S96A Proposal: Level 12 Floor Plan - BOLAN-AAM-BA-22-DP-AR-07112

2.5 Facade

S96A Proposal: Level 22 Floor Plan - BOLAN-AAM-BA-22-DP-AR-07122

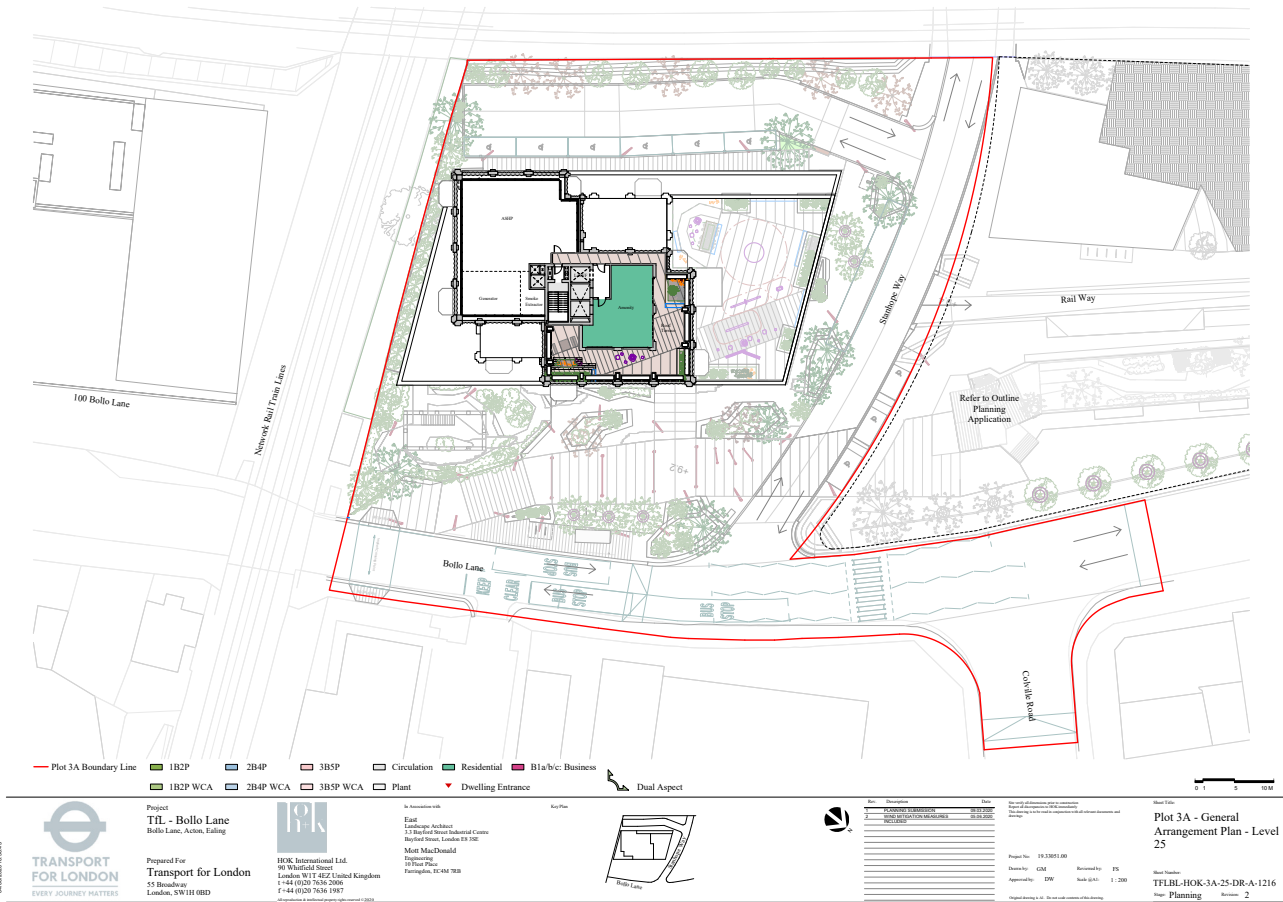
NB:
The S96A amends the Level 22-23 floor plan and Level 24 floor plan to be Level 22 floor plan and Level 23-24 floor plan.

S96A Proposal: Typical brick pier.

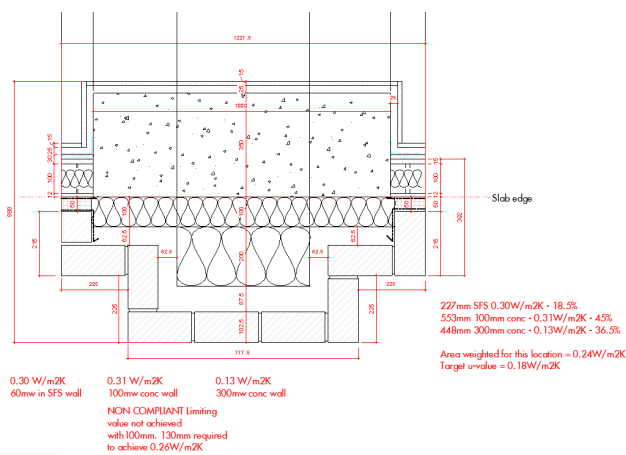
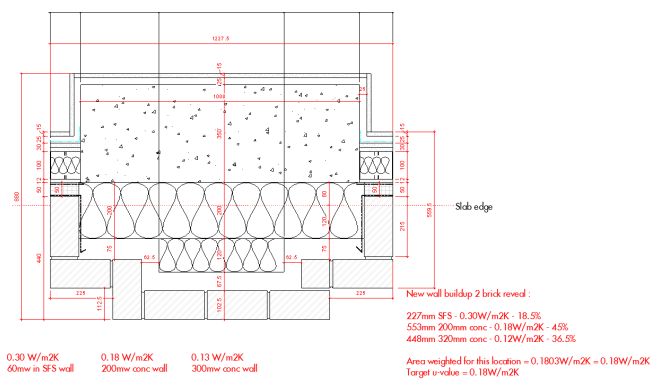
The 2021 Permission incorporates a stepped, two-brick reveal to the pier at 4.5m centres and coordinated with the structural frame behind. This pier design and presence of structural frame leaves an insufficient zone for insulation; unable to achieve the minimum Limiting Value and the required U-value of 0.18W/m2k.

Through design development it has been necessary to increase the cavity to incorporate a minimum 200mm of mineral wool insulation to achieve the designated thermal performance for the building. The proposal reconfigures the two-bricks to the pier design to meet the thermal performance of targets.

S96A Proposal: South East Elevation

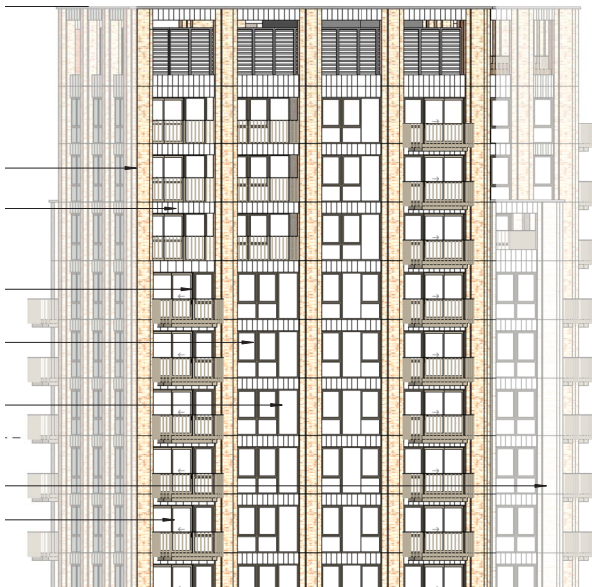
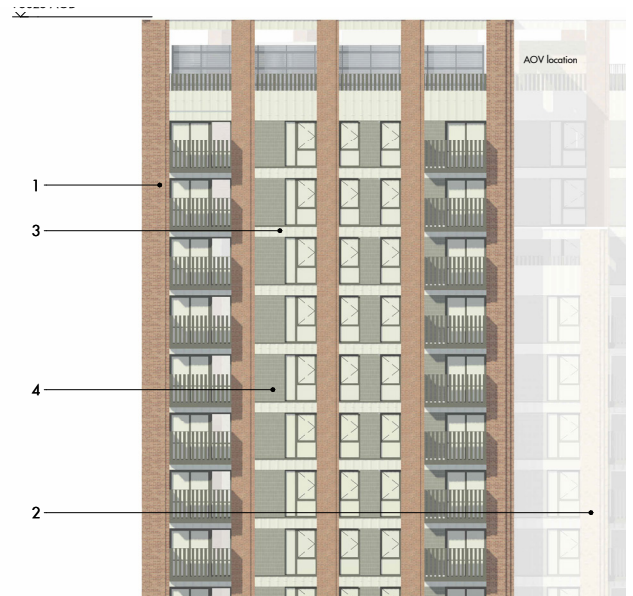
In coordination with the amendments to the fire strategy, apartment layouts and thermal performance the S96A Proposal has developed to reduce the extent of glazing where appropriate and incorporate a masonry infill panel to increase the amount of insulated wall within the scheme.

The masonry infill is conceived of a stack bonded, engineering brick panel that is aligned 25mm back from the face of the stepped brick pier. The brick colour, bond and alignment has been designed to be read as separate to the brickwork of the vertical piers and horizontal beams.

The infill panel simultaneously reduces the extent of glazing and associated internal heat gains whilst increasing the extent of insulated wall improving the thermal performance of the building fabric.
